45700 TWELVE MILE LLC JSP15-49

Consideration at the request of 45700 Twelve Mile Road, LLC for approval of the Preliminary Site Plan and Stormwater Management Plan. The subject property is located in Section 9, on the north side of Twelve Mile Road between West Park Drive and the railroad tracks. The applicant is currently proposing Phase 2 improvements including: pave area for outdoor storage, restore the existing wetland buffer area, install storm water management facilities, install fencing and screening for outdoor storage area and provide curbing for parking and outdoor storage areas throughout the site.

Approval/Denial of the Preliminary Site Plan and Stormwater Management Plan.

Re: 45700 Twelve Mile Road (JSP15-0049)
Wetland Review of the Revised Preliminary Site Plan (PSP15-0127)

Figure 1. City of Novi Regulated Wetland & Woodland Map (approximate property boundary shown in red). Regulated Woodland areas are shown in green and regulated Wetland areas are shown in blue).

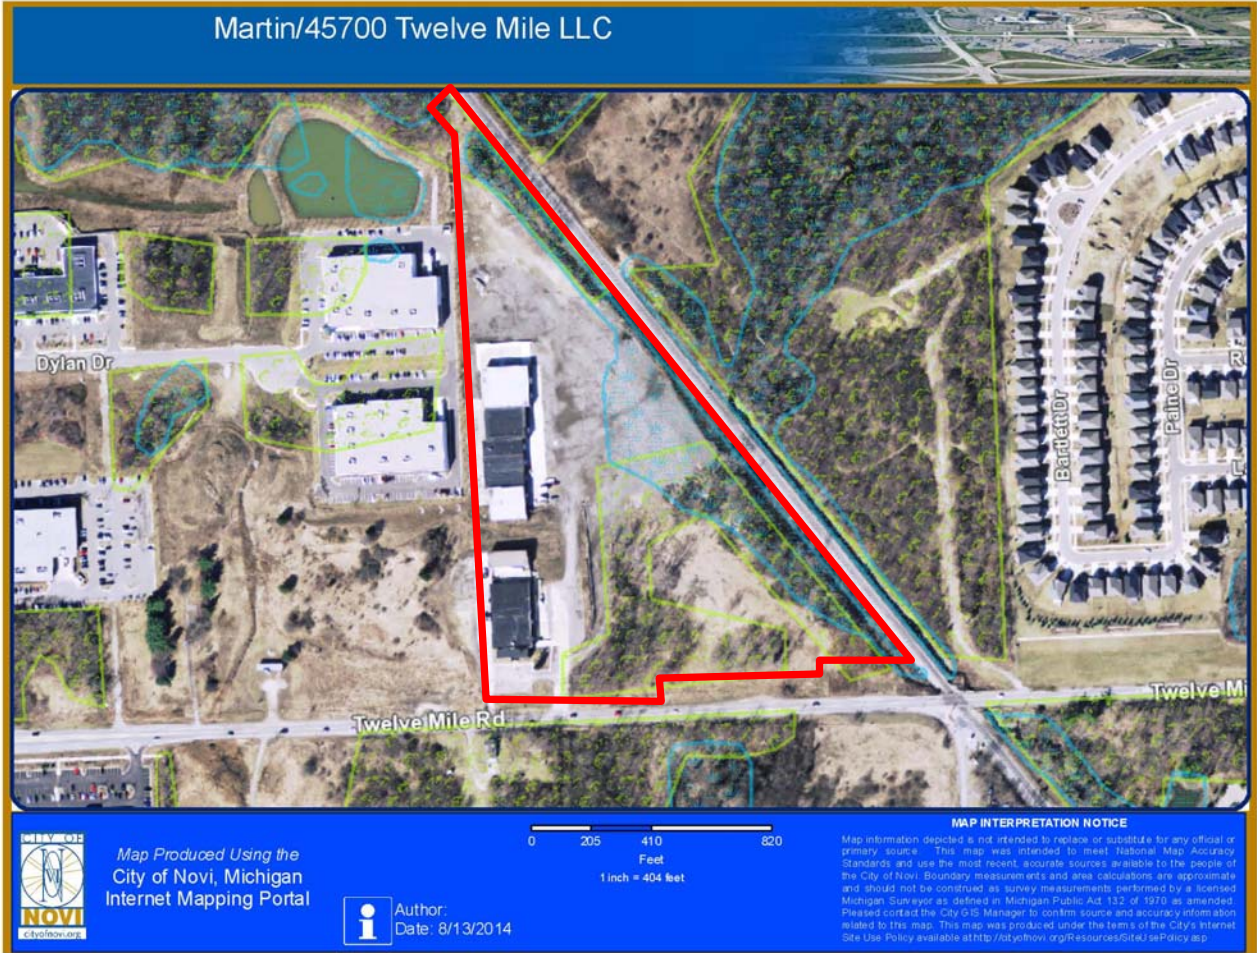
Based on our review of the Plan, Novi aerial photos, Novi GIS, and the City of Novi Official Woodlands Map, it appears that this site contains regulated woodlands; however the proposed limits of disturbance appear to remain outside of those areas designated as regulated woodlands (north and southeast sides of site; see Figure 1).
